Access Compliance Report

Public Rights-of-Way

(Curb Ramps)

Intersection ID: 4052	Main Street: BROWNE'S_FERRY_RD	Cross Street: NEUHOFF_LN	Location:	W
ADA ID: C92B2FFCB5F2	Ramp Type: Perp	Initial Pass/Fail: Fail	Overall Compliance: No	Severity Score: 35
Codes/Mitigation Info/Possible Solution		Field Measurements/Component Compliance

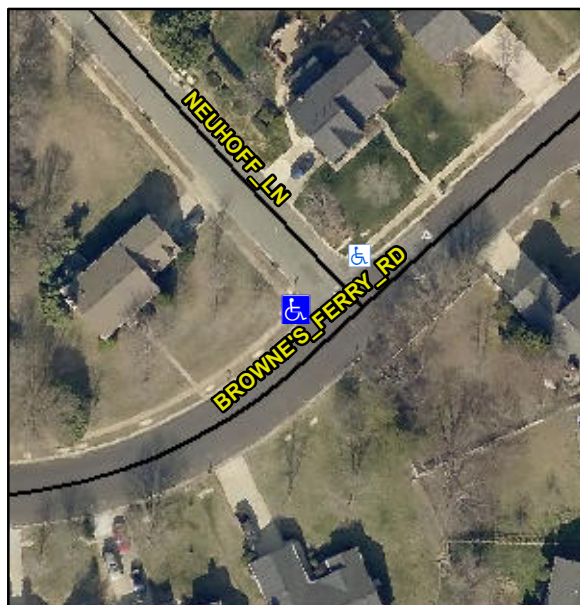
Not Found, R304.5.1

Compliance	Description	Data	Compliance	Description	Data
N/A	Ramp Length (in)	61.5	Yes	Ramp Slope (%)	5.2
No	Ramp Width (in)	28.0	Yes	Ramp XSlope (%)	1.7
N/A	Flare Type LT	N/A	N/A	Flare Type RT	N/A
N/A	Flare Slope LT (%)	N/A	N/A	Flare Slope RT (%)	N/A
N/A	Flare Traversable LT?	N/A	N/A	Flare Traversable RT?	N/A
N/A	Landing Length (in)	N/A	N/A	DWS Provided?	N/A
N/A	Landing Width (in)	N/A	N/A	DWS Contrast?	N/A
N/A	Landing Slope (%)	N/A	N/A	DWS Length (in)	N/A
N/A	Landing X Slope (%)	N/A	N/A	DWS Full Width?	N/A
N/A	Landing Curb? (Y/N)	N/A	N/A	DWS Offset (in)	N/A
N/A	Shared Landing?	N/A			
N/A	Gutter Ponding?	N/A	N/A	Gutter Slope (%)	N/A
N/A	Gutter Lip Ht (in)	N/A	N/A	Gutter X Slope (%)	N/A
N/A	Painted X Walk1?	No	N/A	Painted X Walk2?	N/A
	X Walk 1 Direction	To NE		X Walk 2 Direction	N/A
N/A	X Walk 1 Width (in)	N/A	N/A	X Walk 2 Width (in)	N/A
	X Walk 1 Slope (%)	4.1		X Walk 2 Slope (%)	N/A
	X Walk 1 X Slope (%)	2.8		X Walk 2 X Slope (%)	N/A

Remove & Replace Entire Ramp.
